1989 - 1990 Corvette: Service Bulletin: Convertible Stowage Lid Not Flush With Rear Deck

Source: Chevrolet Dealer Service Bulletin

Number: 90-183-10 - (02/20/1990)

Subject: STOWAGE LID NOT FLUSH W/REAR DECK-PROCEDURE & STEEL RIVETS

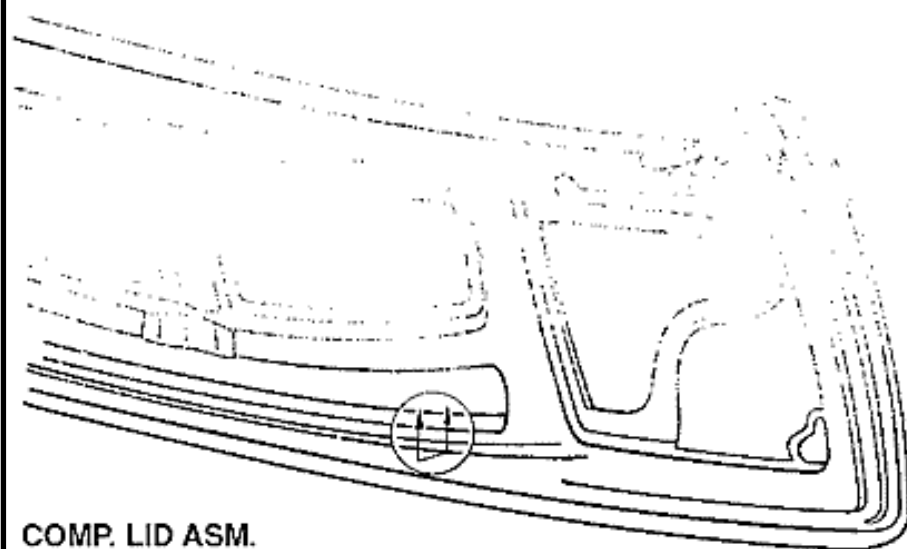
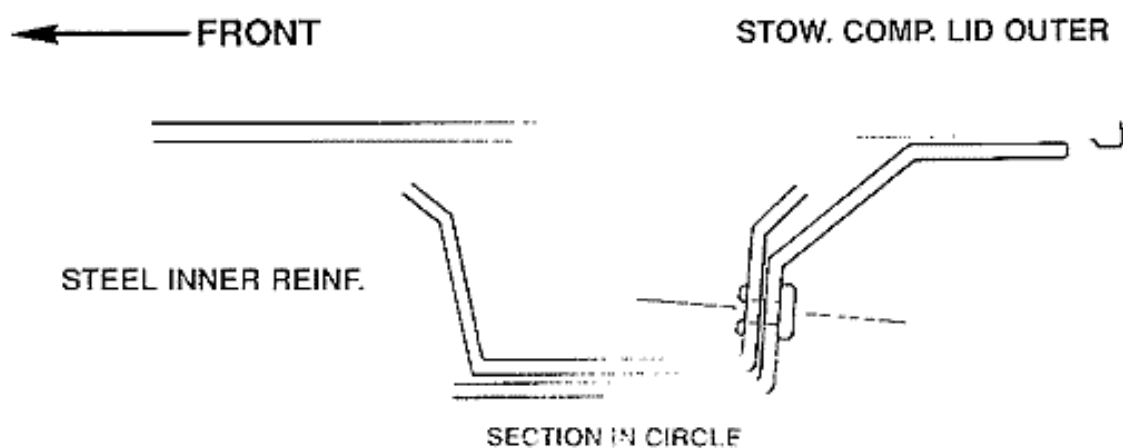
Some 1989 and early 1990 Chevrolet Corvette Convertibles may exhibit a height difference between the stowage compartment lid and the rear deck. This condition may be caused by a lack of adhesive between the steel inner reinforcement and the stowage compartment lid inner panel.

1. Remove the stowage lid as outlined in the Service Manual.
2. Drill 8 (eight) equally spaced 1/8 inch holes through the vertical surface (See Figure 1) of the stowage lid inner panel and the reinforcement.

IMPORTANT: Use a Drill Stop Set at a Depth of 1 inch when drilling these holes in order to prevent damage to the compartment lid.

3. Install 1/8 inch diameter X 1/4 inch long STEEL rivets in the holes.

IMPORTANT: Do not use aluminum rivets as they will not provide the strength necessary to keep the lid from bowing.

4. Coat the rivet heads with touch-up paint to prevent rust.
5. Replace stowage lid as outlined in the Service Manual.

1. REMOVE STORAGE COMPARTMENT LID FROM VEHICLE AND LAY UPSIDE DOWN ON A CLEAN PROTECTED SURFACE.
2. HOLD WEATHERSTRIP OUT OF THE WAY AND DRILL EIGHT (8) $1/8$ " HOLES IN BACK SIDE THROUGH INNER PANEL AND STEEL REINFORCEMENT (4 HOLES ON EACH SIDE OF CENTER EQUALLY SPACED).
3. INSTALL APPROPRIATE TAPPING SCREW ($5/16$ " LONG) OR STEEL RIVET ($1/8$ " X $1/4$ ").
